Re: Questions by Email.

FCC ID: H9PNP3010
Date: April 16, 1999

Re: FCC ID H9PND3010
Applicant: Symbol Technologies Inc
Correspondence Reference Number: 7793
731 Confirmation Number: EA93911
Date of Original E-Mail: 05/14/1999

Attachment A

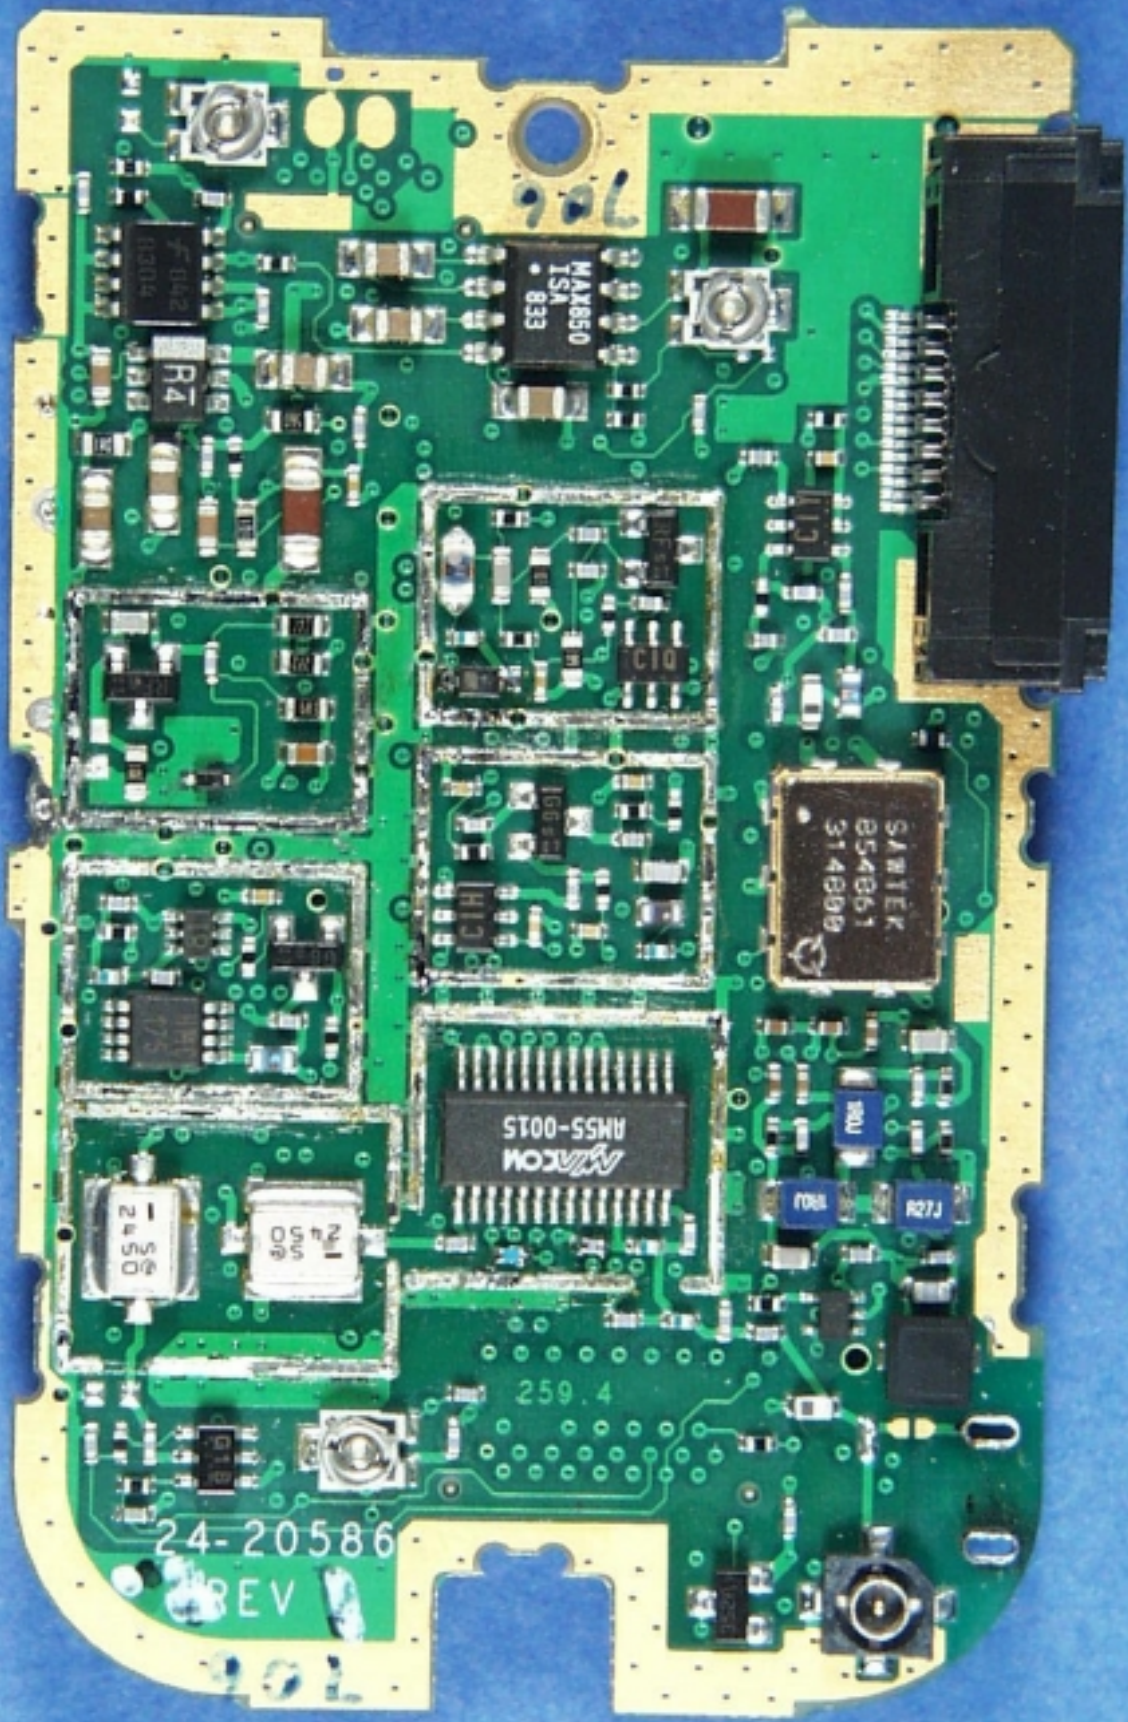
2) *The photo's of both sides of the RF board contain too many shields. Please provide photo's without the shields.*

Please see Attachment A.

Attachment B

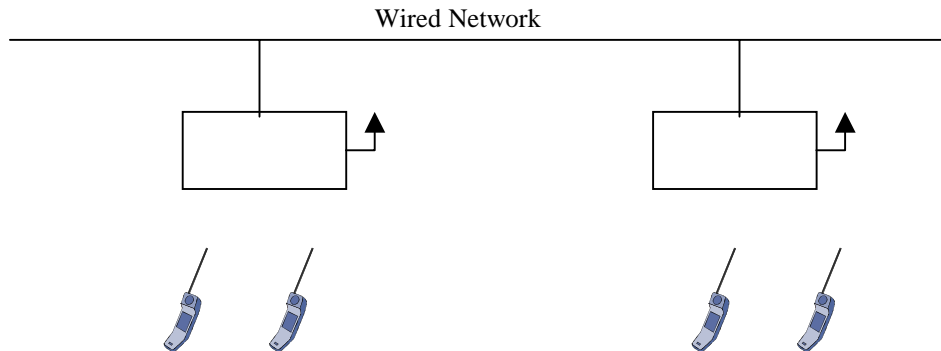
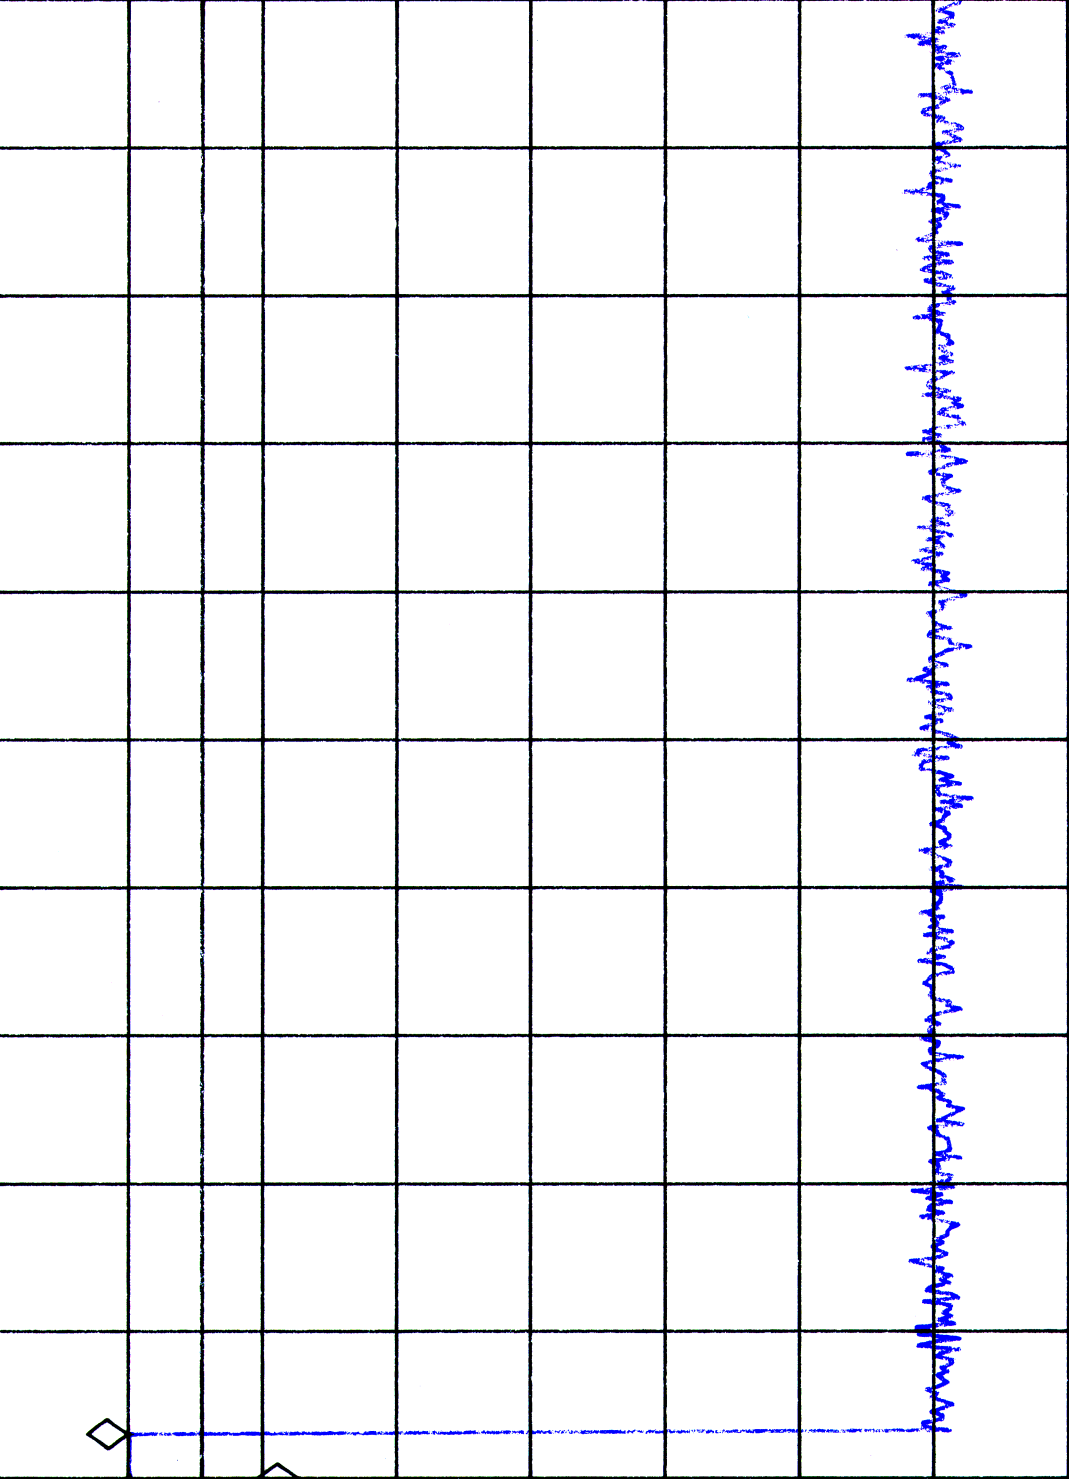
4) *With regard to the radiate emission test data, a duty cycle factor of 10 dB was used. However, the dwell time was 100 msec. Since the duty cycle is the on time per 100 msec, the duty cycle should have been 0 dB. Please explain/correct accordingly.*

Unfortunately the emissions test software was running on the DUT when the dwell plot was taken. Attachment B explains the duty cycle with the operational software loaded and contains the correct dwell plot.

The communications from the NetVision Phone to the Access Point begins with the NetVision Phone listening (in receive mode, transmitter off) to determine if any other transmission is under way the listening takes place for at least 0.1 msec. The NetVision Phone then transmits a maximum packet size of 32 bytes of voice data, with addressing and other packet overhead the packet size is 112 bytes at 1 Mbit per second the packet time is $112 \text{ bytes} \times 8 \text{ bits/byte} / 1 \text{ Mbitsec} = 0.896 \text{ msec}$. The Access Point replies with an acknowledgment in 0.02 msec the acknowledgment packet is 0.2 msec long and during the acknowledgment packet the NetVision Phone is in receive mode (transmitter is off). The NetVision Phone typically sends one packet every 30 msec but can send a maximum of 12 packets in any 100 msec interval. Therefore the NetVision Phone transmit duty cycle is:

Maximum transmit time in 100 msec interval $\leq (12 \text{ packets}) (0.896 \text{ msec/packet})$

Maximum transmit time in 100 msec interval = 10.75 msec.

Duty Cycle \leq Maximum NetVision Phone transmit time / 100 msec

Duty Cycle $< 10.75 \%$

The correction factor is then $20 \log (.1075) = 19.37 \text{ dB}$.
